Affected Models: see attached
Any 2003 Chief
built before 3-31-03
is suspect

Service Bulletin

Bezel Warning Lights

Normal Condition

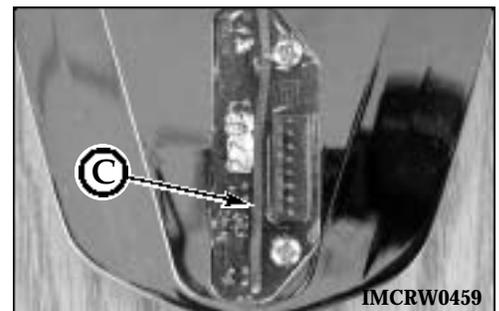
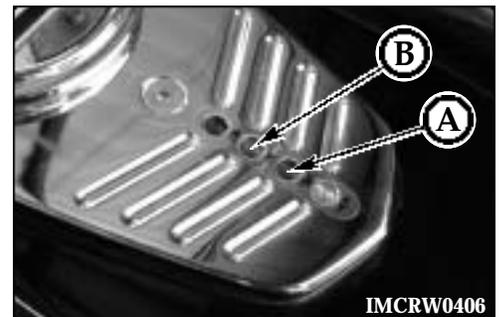
Some bezel warning light circuit boards have an electrical fault causing the Green Neutral Light to be significantly dimmer than the Red Oil Pressure Light. It is important to correctly identify the fault before replacing the circuit board as the green light is naturally dimmer than the red.

To see the lights easier, position the bike out of direct sunlight, preferably inside the workshop. Turn the ignition key on and place the bike in neutral. The red Oil Pressure Light (A) will shine brightly while the Green Neutral Light (B) will be dimmer. This is a normal condition. Start the motorcycle and observe the neutral light. The Green Neutral Light will not get brighter.

If after starting the bike the brightness of the Green Neutral Light becomes significantly brighter than a fault condition may exist. If you suspect a fault (dimmer than normal) condition remove the bezel from the dash. Turn the bezel over and view the printed circuit board. Look for a red strip upon the board (C). A bezel with a red stripe is the most current board. Boards without the stripe are suspect but NOT assumed to be bad.

Again, do not assume a board without the red strip is faulty. Many boards without the red strip perform normally and will remain that way through out the life of the motorcycle.

New Instrument Bezel

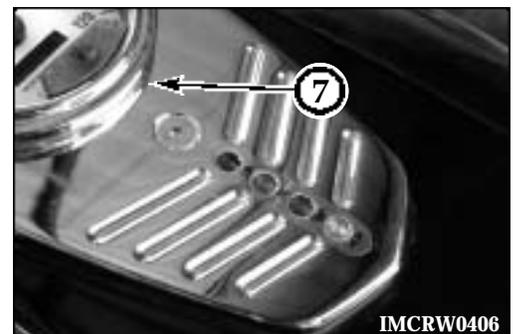
- 7 Fit the speedometer to the new instrument bezel. Ensure the seal and flange seat firmly against the bezel surface.

- 8 Secure the speedometer to the bezel with the bracket, washers and nuts. Tighten the nuts to 5^{1/2} inch-pounds +/- 1/2.

CAUTION: DO NOT over torque the nuts. Over torquing deforms the plastic case and will allow water to leak into the speedometer.
